ADDENDUM C

NORTH PARK MINI PARK

BID NO.:	<u>K-20-1864-DBB-3</u>
SAP NO. (WBS/IO/CC):	<u>S-10050</u>
CLIENT DEPARTMENT:	<u>1714</u>
COUNCIL DISTRICT:	<u>3</u>
PROJECT TYPE:	<u>GC</u>

A POINT OF CONNECTION LAYOUT BLOW-UP PLAN

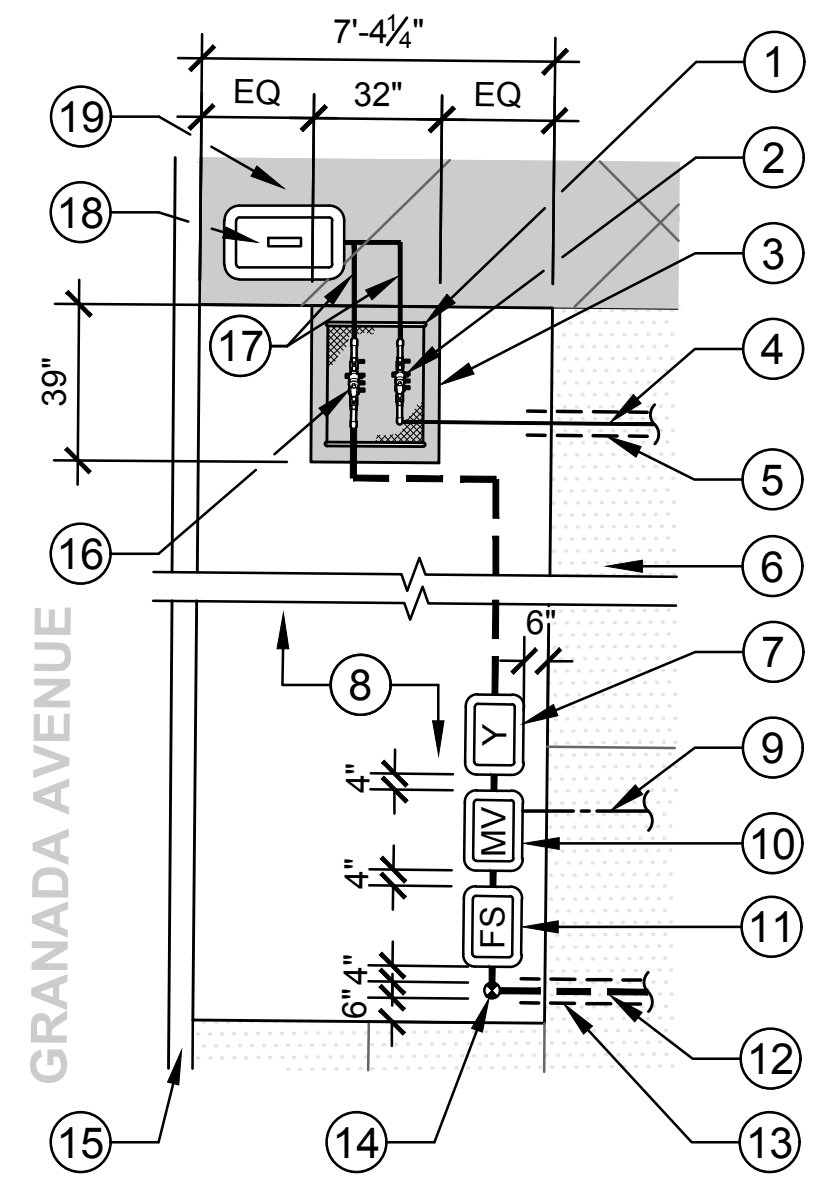
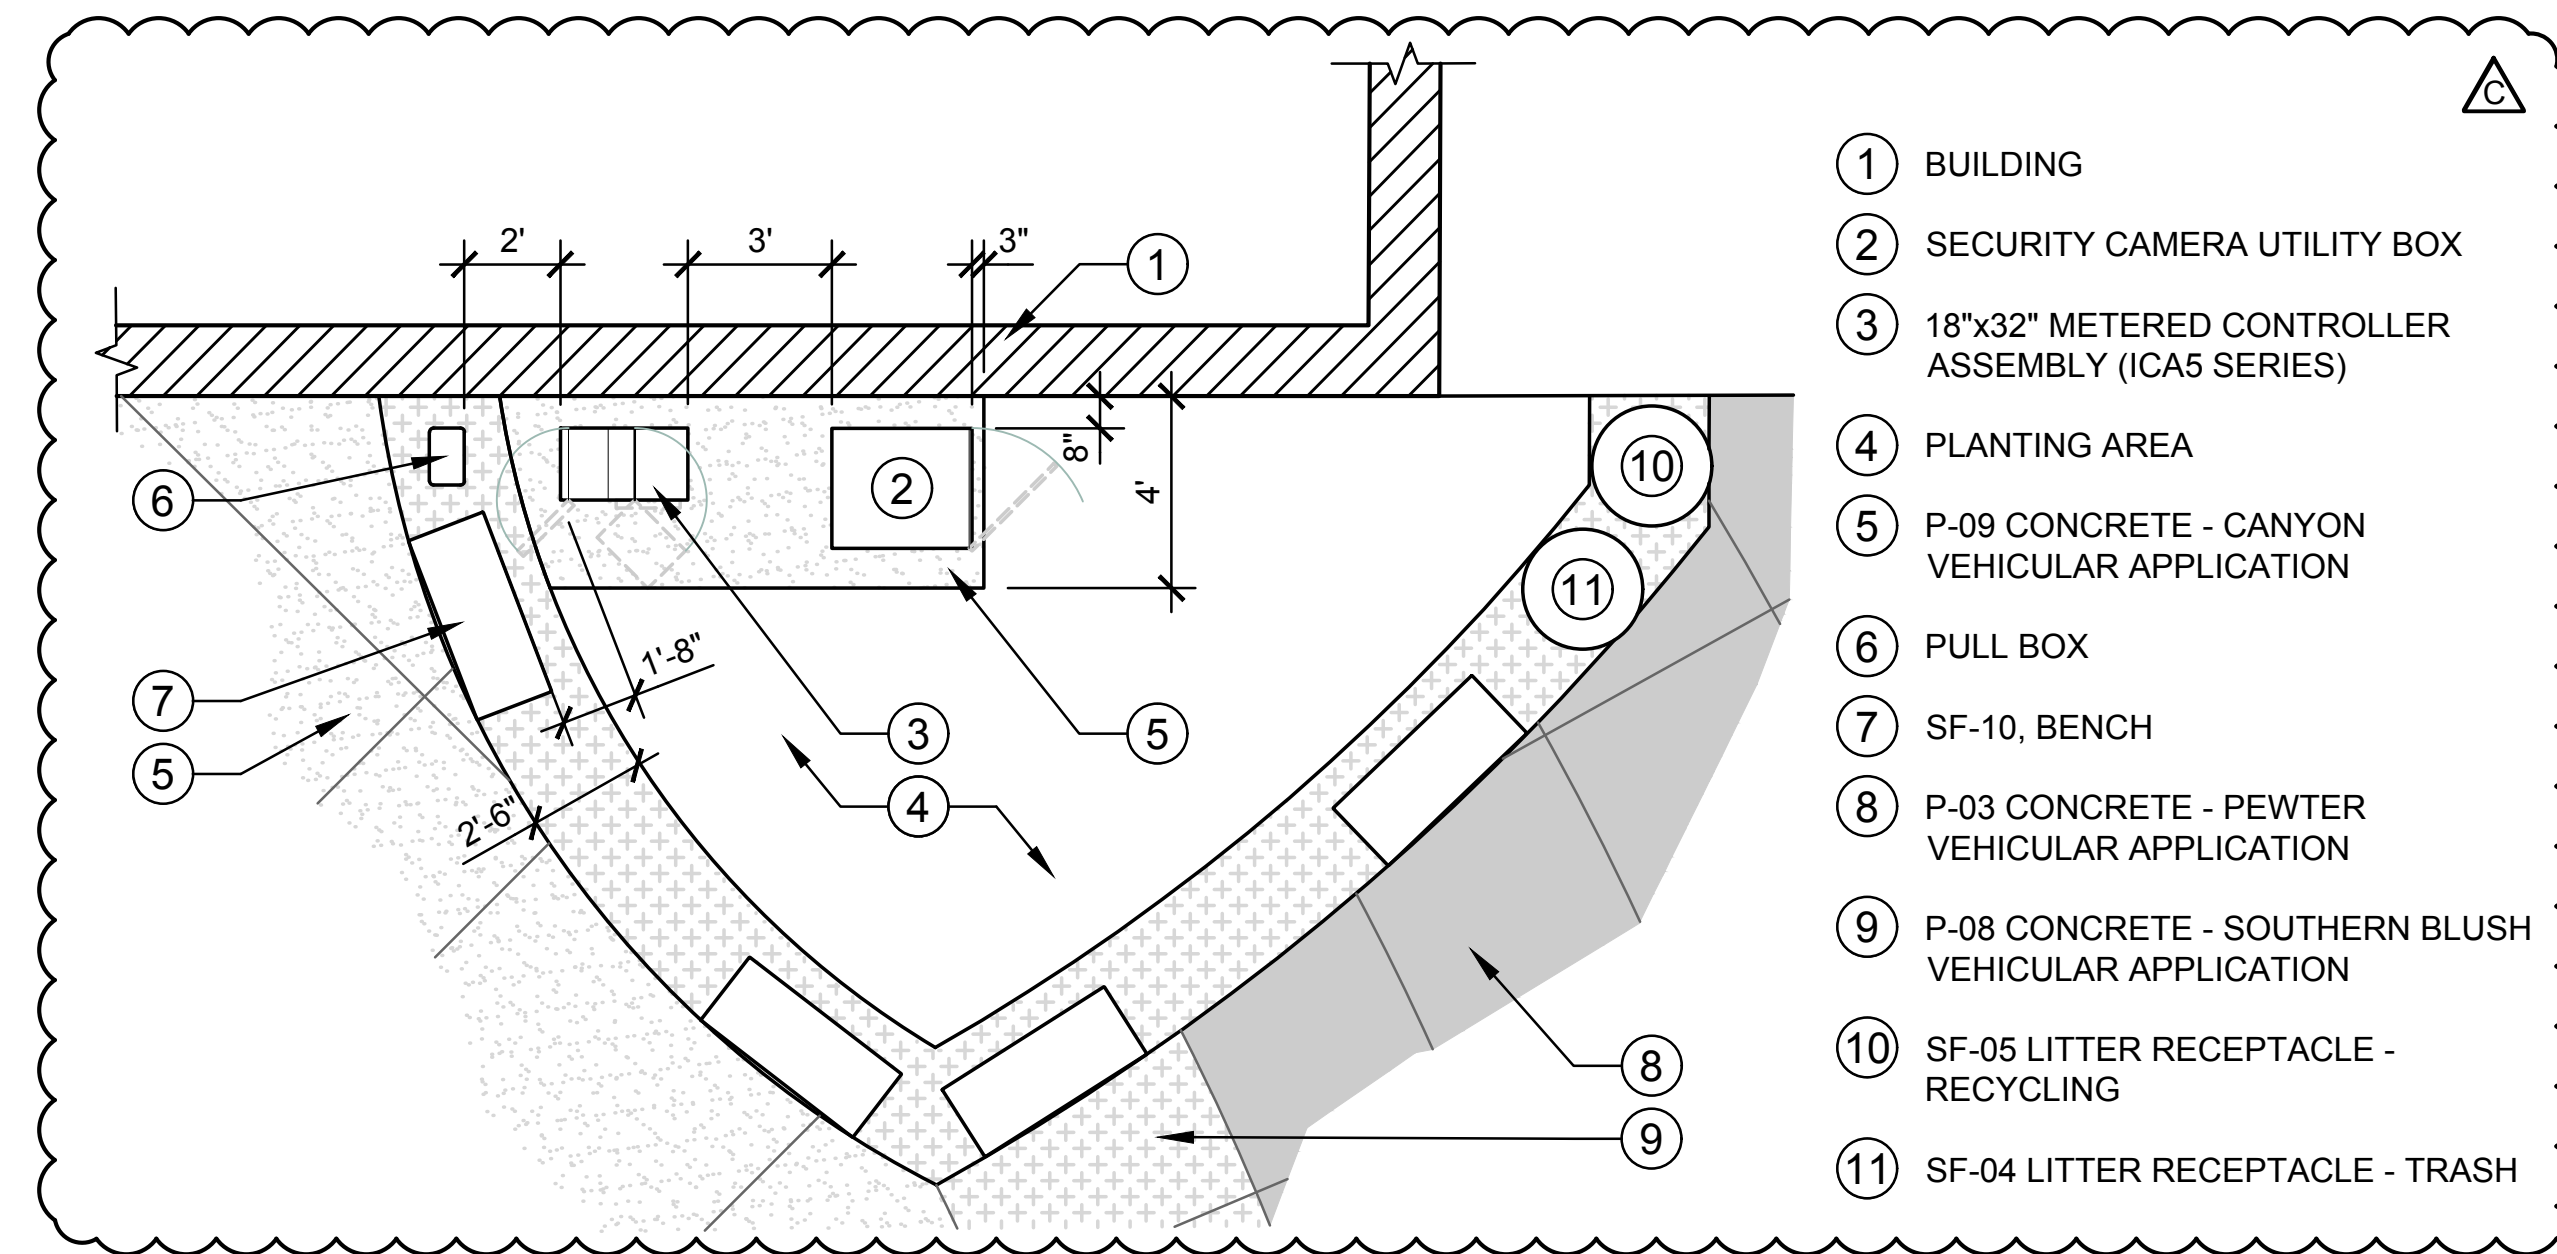
CHANGES TO PLAN. IRRIGATION ALTERED.

PLANTING LEGEND

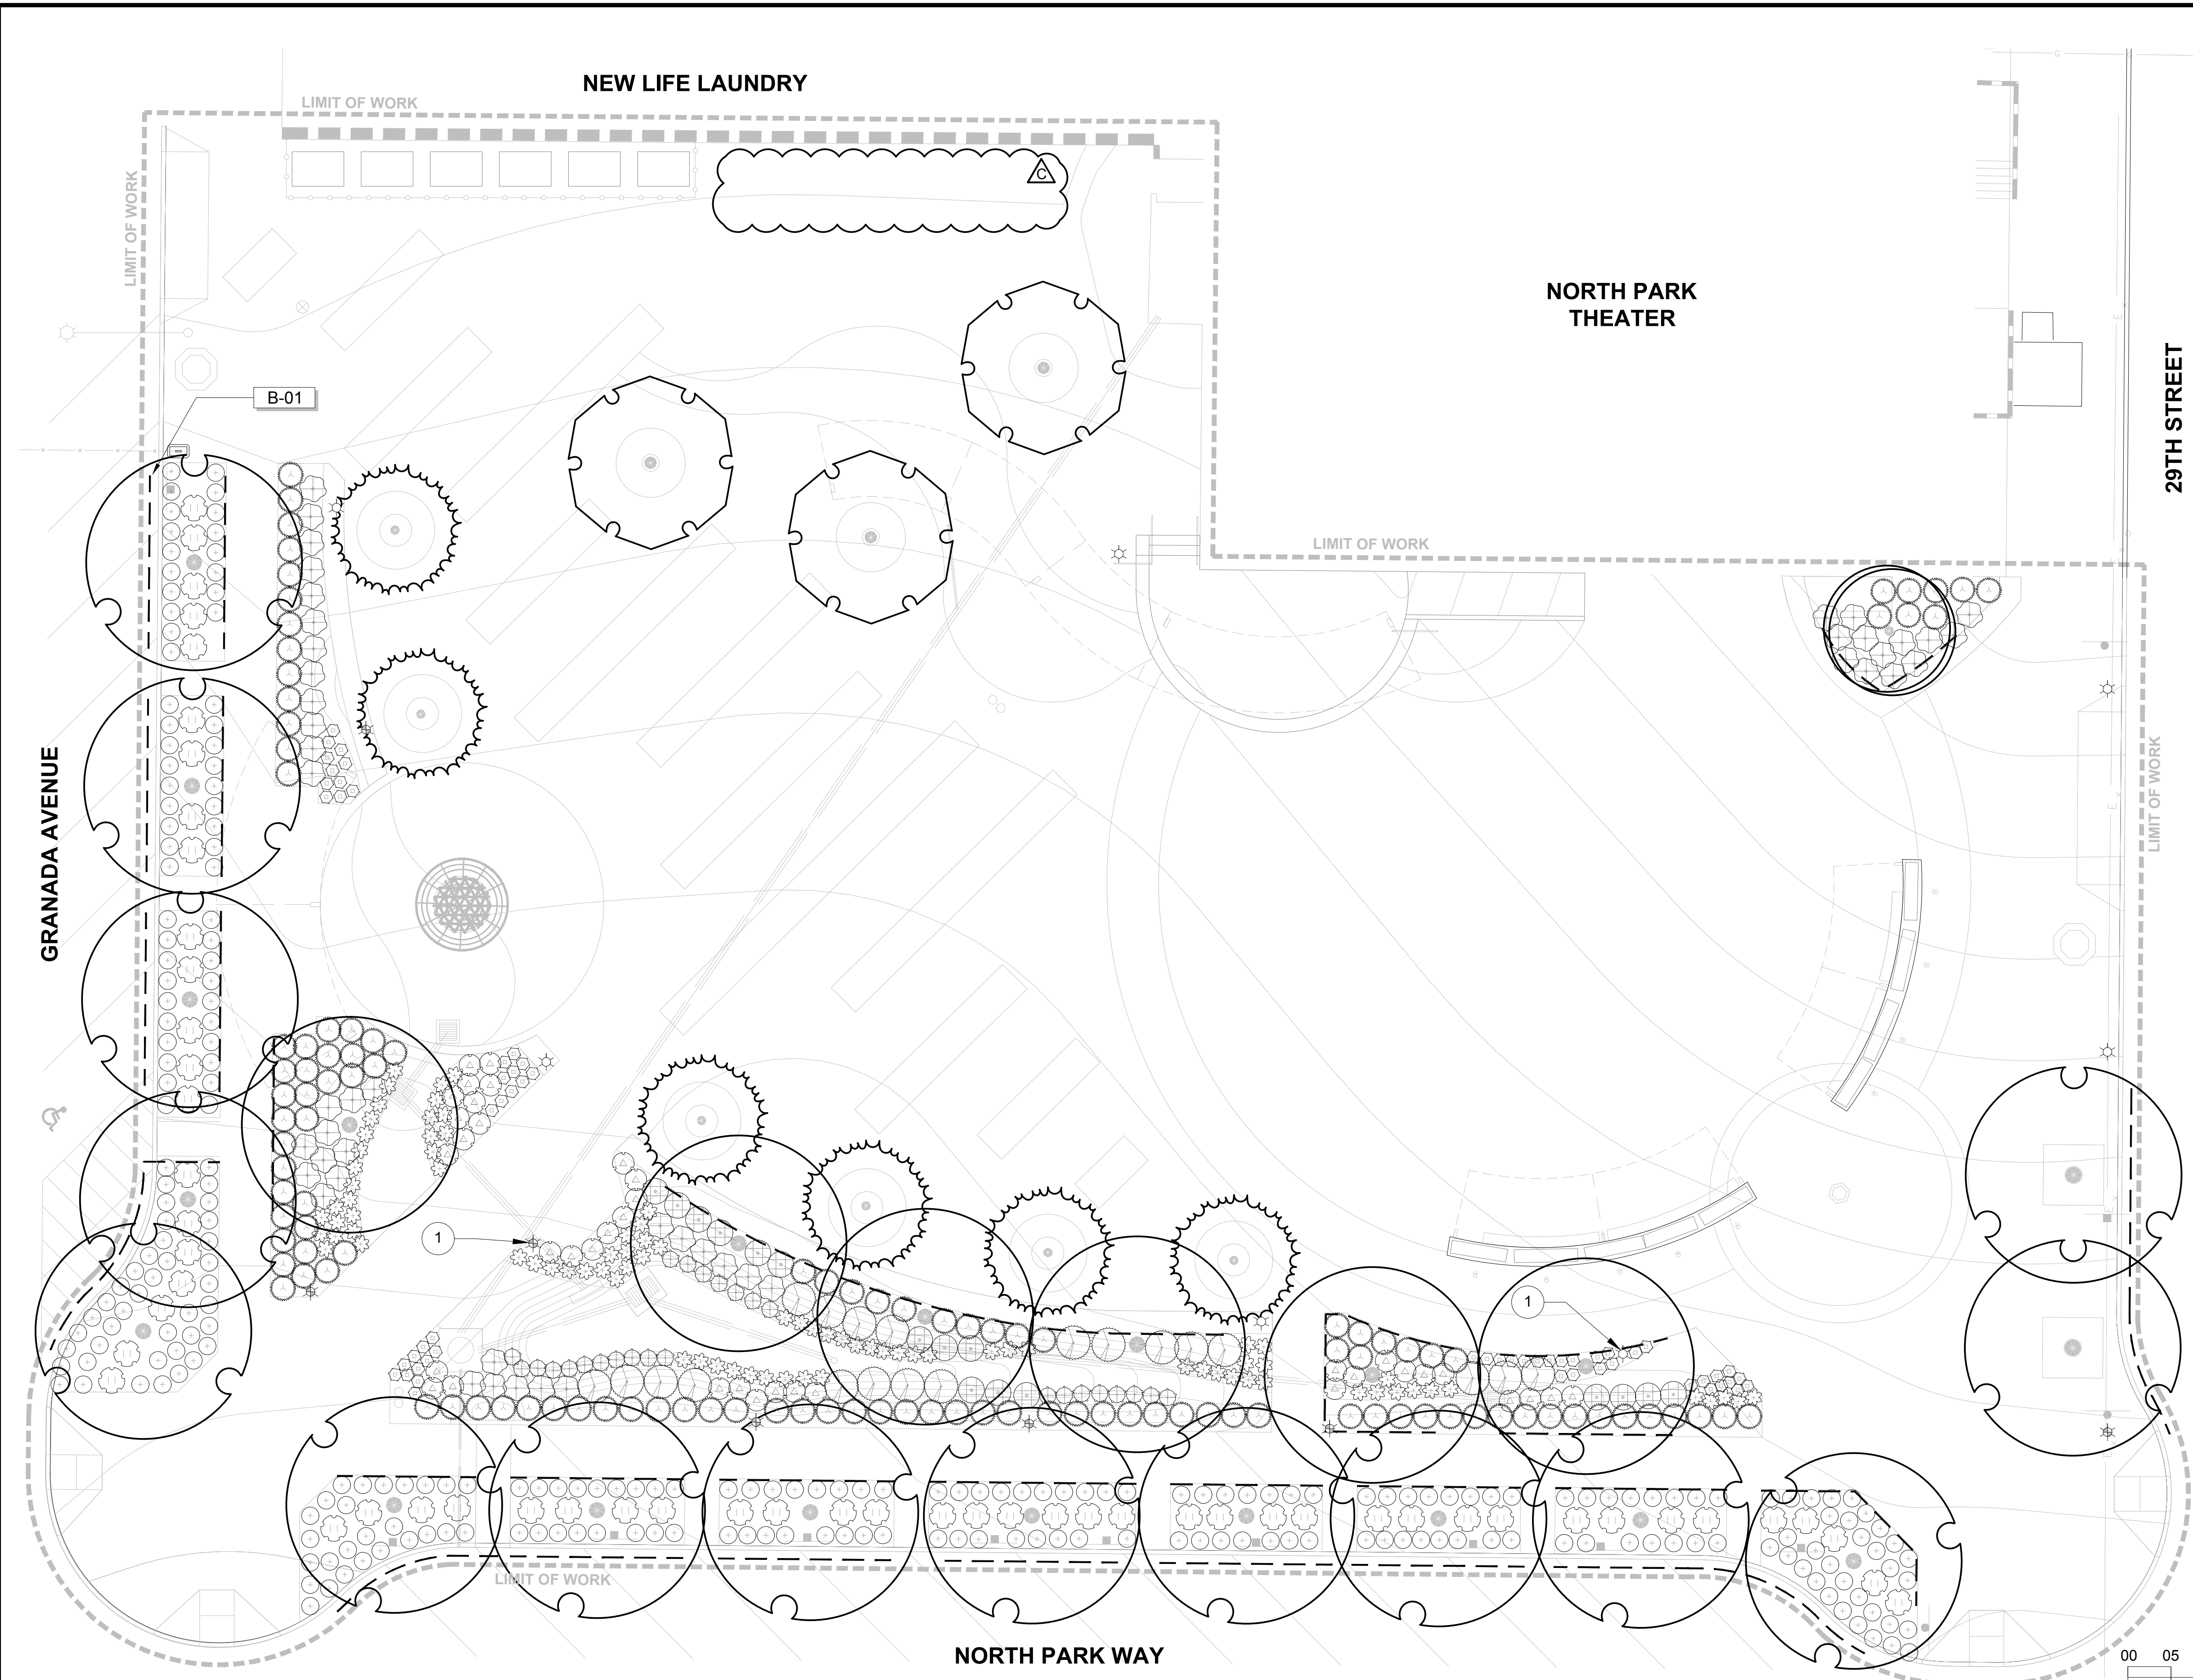
CHANGES TO PLAN. STORAGE CONTAINER REMOVED.
